2016/11/30

MCMI- Ø8 、 Ø10 、 Ø12 end covers design change notification

MCMI-Ø8 、 Ø10 、 Ø12 front and rear covers

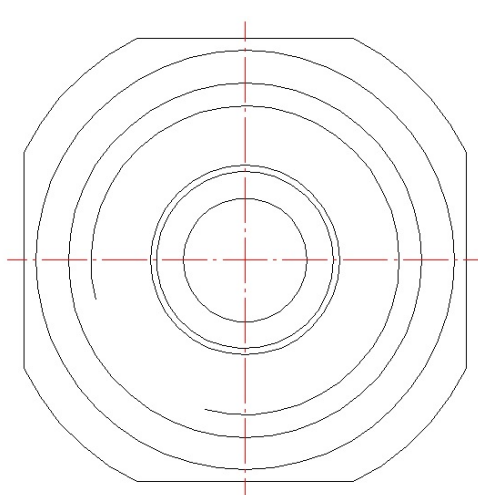
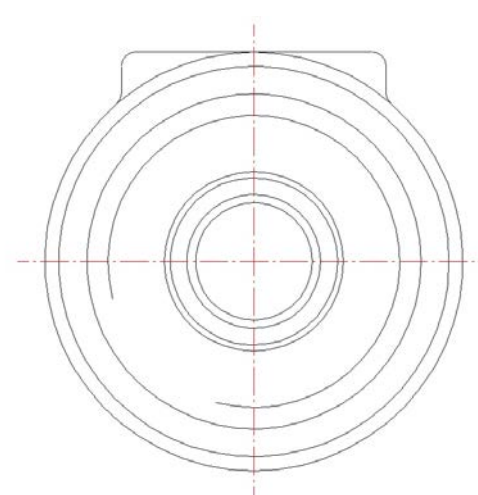
To unify appearances of MCMI end covers, the end cover appearances of MCMI-Ø8, Ø10 and Ø12 are changed based on MCMI-Ø16 and above.
